Intersection ID: 53631	Main Street: PROVIDENCE_RD_WEST	Cross Street: BEACON_VALLEY_ST	Location:	NE
ADA ID: 6B2DD06F6B40	Ramp Type: Perp	Initial Pass/Fail: Fail	Overall Compliance: No	Severity Score: 8.75

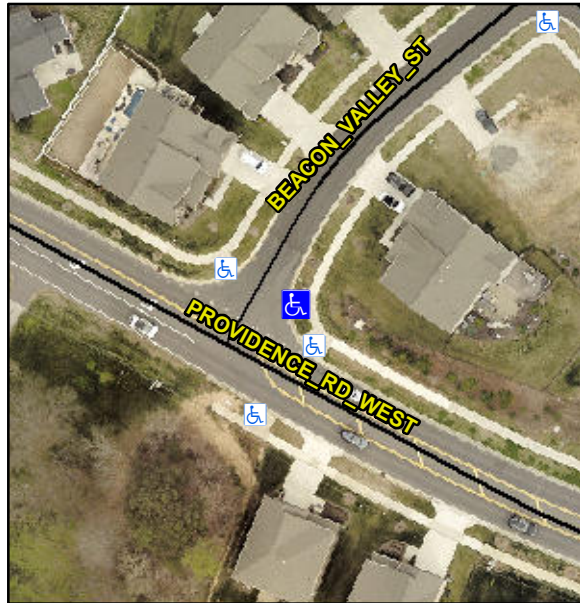
### R304.5.1

Compliance	Description	Data	Compliance	Description	Data
N/A	Ramp Length (in)	97.0	Yes	Ramp Slope (%)	5.7
No	Ramp Width (in)	44.0	Yes	Ramp XSlope (%)	1.8
N/A	Flare Type LT	N/A	N/A	Flare Type RT	N/A
N/A	Flare Slope LT (%)	N/A	N/A	Flare Slope RT (%)	N/A
N/A	Flare Traversable LT?	N/A	N/A	Flare Traversable RT?	N/A
N/A	Landing Length (in)	N/A	N/A	DWS Provided?	N/A
N/A	Landing Width (in)	N/A	N/A	DWS Contrast?	N/A
N/A	Landing Slope (%)	N/A	N/A	DWS Length (in)	N/A
N/A	Landing X Slope (%)	N/A	N/A	DWS Full Width?	N/A
N/A	Landing Curb? (Y/N)	N/A	N/A	DWS Offset (in)	N/A
N/A	Shared Landing?	N/A			
N/A	Gutter Ponding?	N/A	N/A	Gutter Slope (%)	N/A
N/A	Gutter Lip Ht (in)	N/A	N/A	Gutter X Slope (%)	N/A
N/A	Painted X Walk1?	No	N/A	Painted X Walk2?	N/A
	X Walk 1 Direction	To NW		X Walk 2 Direction	N/A
N/A	X Walk 1 Width (in)	N/A	N/A	X Walk 2 Width (in)	N/A
	X Walk 1 Slope (%)	3.8		X Walk 2 Slope (%)	N/A
	X Walk 1 X Slope (%)	3.8		X Walk 2 X Slope (%)	N/A

### Remove & Replace Entire Ramp.
